Apple Valley 84

Town of Apple Valley, California

Final Environmental Impact Report SCH No. 2025100104

Final Environmental Impact Report

Figure 3-4

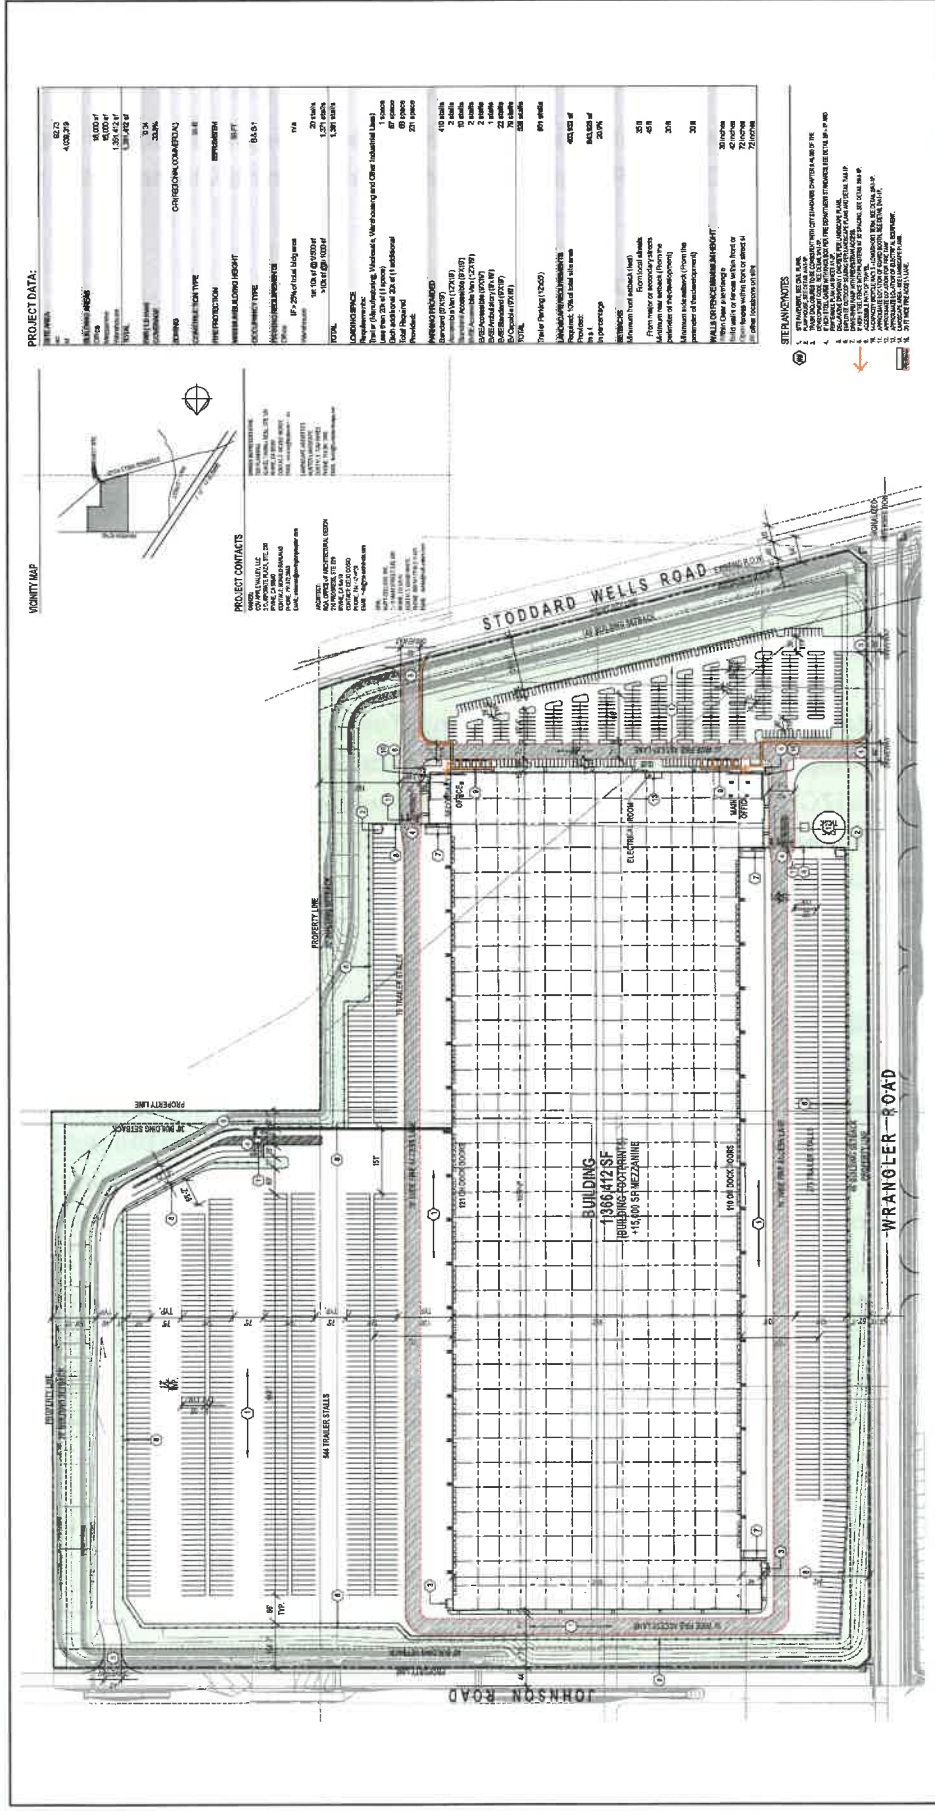
3. Figure 3-4, *Site Plan* is hereby modified due to updated site plan configurations.
